Product Change Notification

PCN-PCC-8043-2022

Business Unit	Product Line Code	Type of Change	Action	Date of Issue
PCC - PCB Connectors	AAC	Product Change Notification	Notify Distributors and Field	7/18/2022

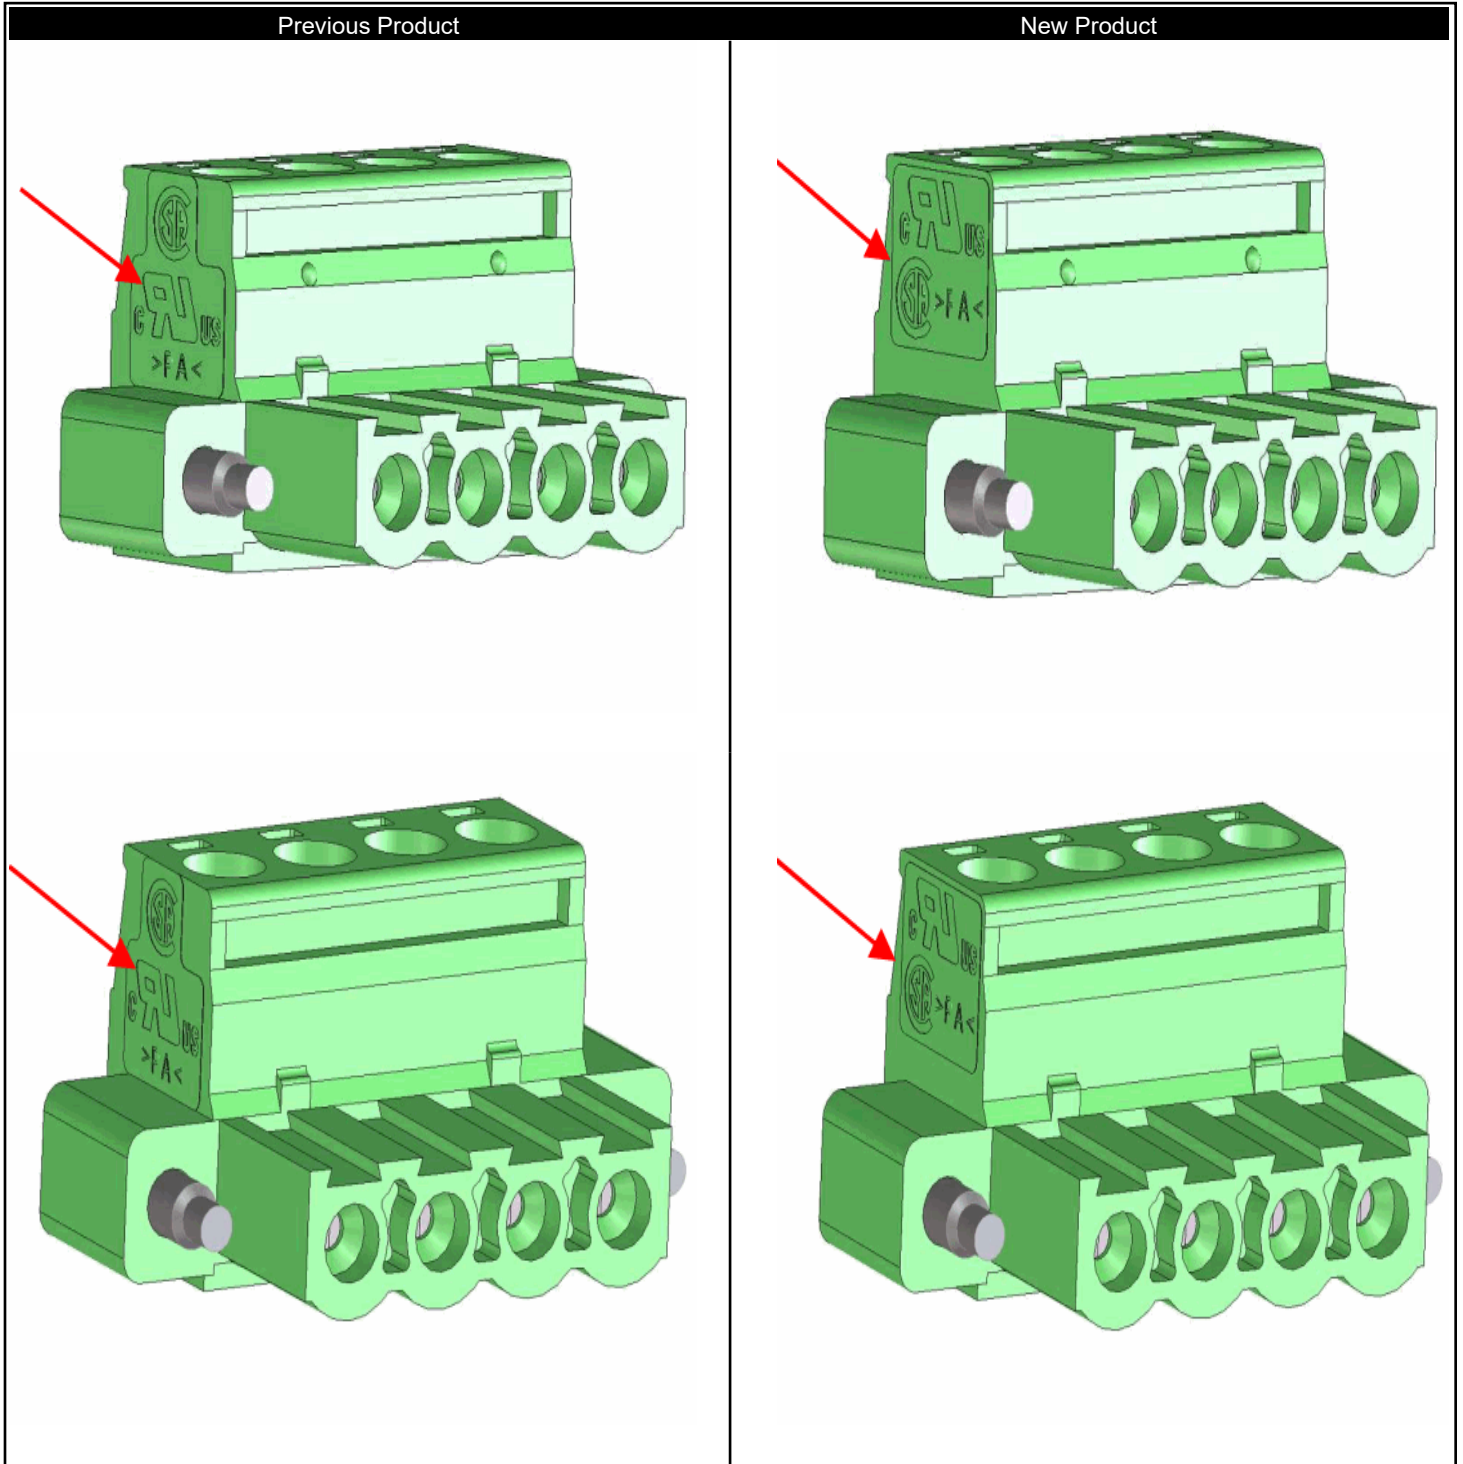
Description for Product Change Notification
The construction of new injection molding tools for MSTB 2,5/...-STF with 2-position through 8-position will be used to adapt the lettering fields to match the design used by other MSTB 2,5/...-ST connector families. A visual comparison of old / new is provided below within this document. The external dimensions, technical data, and approvals remain unchanged. The existing tools will continue to produce the old lettering field. This will gradually be replaced with the new version over the coming years.
